SUBJECT: Deficiency rept re possible operability loss of Borg-Warner valves w/limitorque series SMC operators. Identified valves will be reworked by thread staking procedure. Schedule to be provided after labor negotiations.

Subject: WPPSS Nuclear Project No. 2
Docket No. 50-397, CPPR-93
Reportable Deficiency - 10CFR50.55(e)

REPORTABLE DEFICIENCY AND CORRECTIVE ACTION
WPPSS NUCLEAR PROJECT NO. 2
POSSIBLE LOSS IN OPERABILITY OF BORG-WARNER-NDV VALVES
WITH LIMITORQUE SMC SERIES ACTUATORS

FIGURE 1.

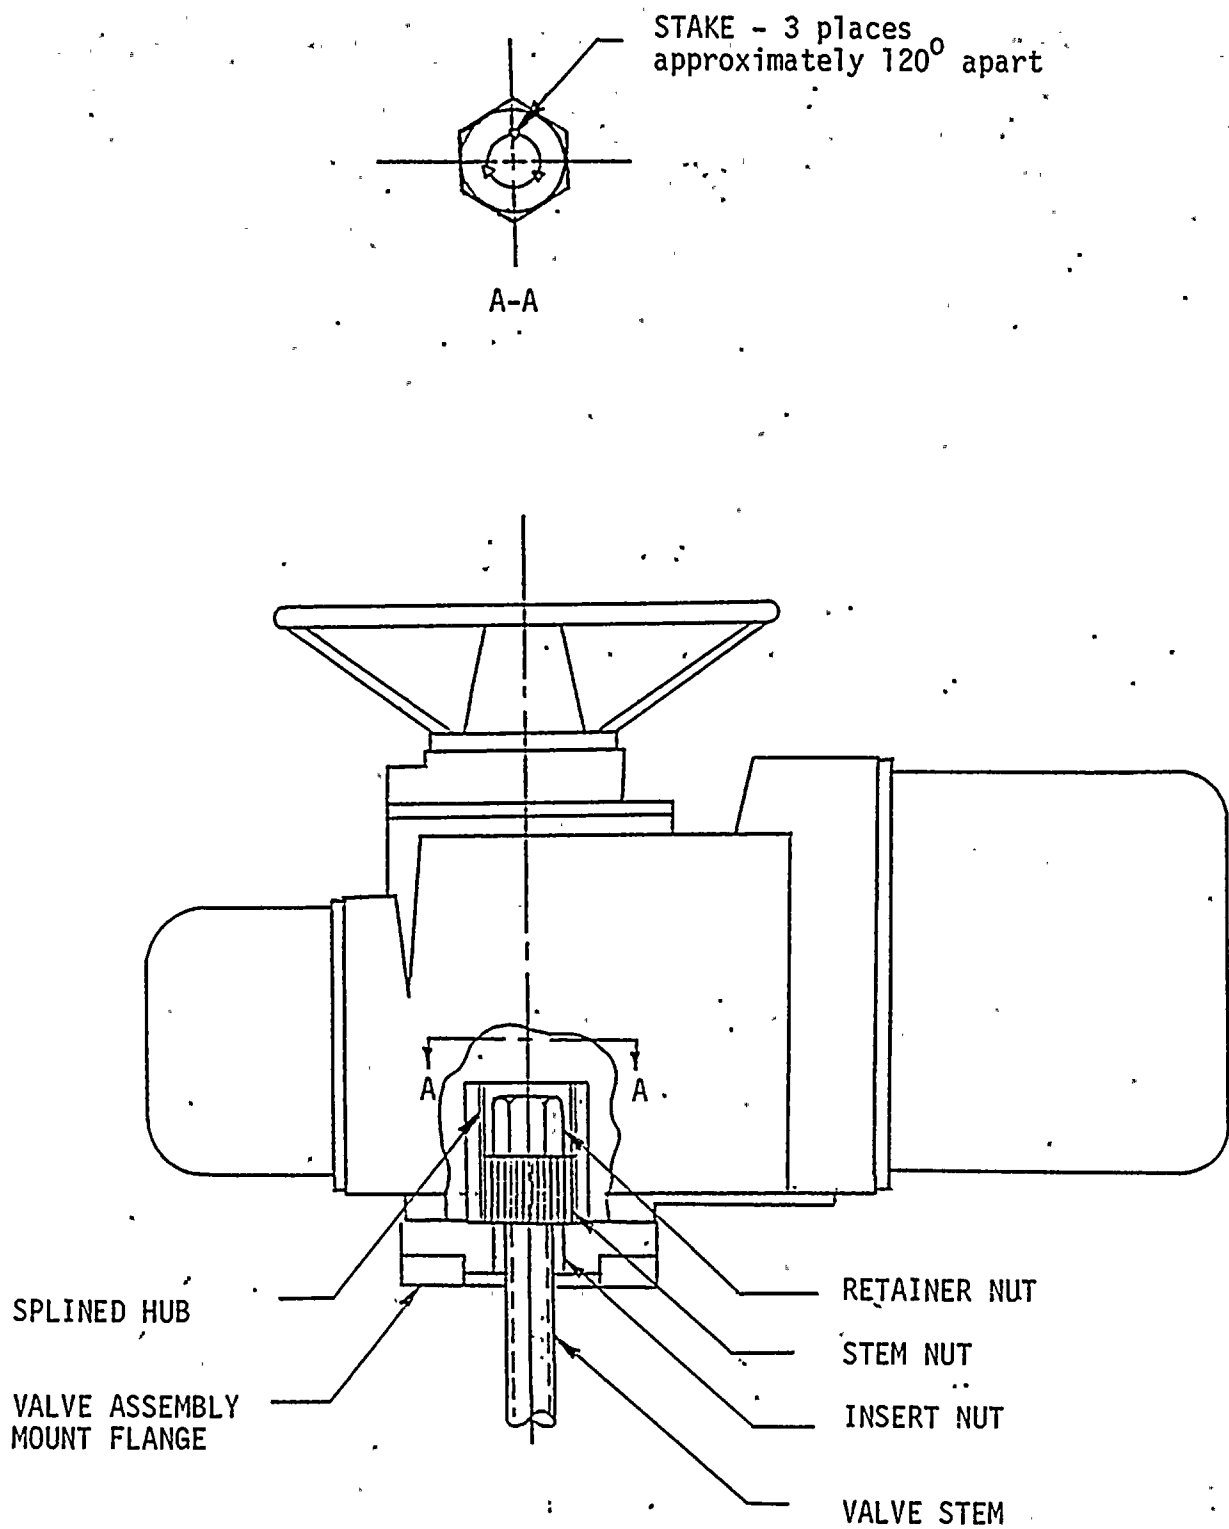
The reported deficiency involves the possible loosening of the stem nut on some Borg-Warner Nuclear Valve Division valves equipped with Limitorque SMC series operators. Loosening of the stem nut could result in disengagement of the connection between the valve and operator, rendering the valve inoperable.

The deficiency is similar to that reported by NRC IE Circular 79-04, however, the design of the connection between the valve and operator is not the same as described by the Circular and involves components provided by the valve manufacturer. The design, for which the deficiency is reported, applies to valves with threaded rising stems that rotate. The required axial movement of valve stem is provided by the interaction between the valve stem threads and a fixed insert nut installed in a flange fitting between the valve assembly mount flange and the operator. Rotation of the valve stem is provided by a splined stem nut which mates with splines in the hub of the operator drive gear. The stem nut, which has a square socket to mate with a squared section of the valve stem, is retained by a nut on the end of the valve stem. The stem nut moves axially with the valve stem as the valve opens or closes. Loosening or loss of the retainer nut could result in movement of the stem nut to a point that the connection between the valve and operator disengages.

The Borg-Warner Nuclear Valve Division has developed a method of correcting the reported deficiency which involves staking the threads of the valve stem and retainer nut as indicated on Figure 1. This staking procedure has been tested with very satisfactory results.

All of the valves, which have been identified, will be reworked in accordance with Borg-Warner's recommendations. The rework will be supervised and checked by Borg-Warner personnel.
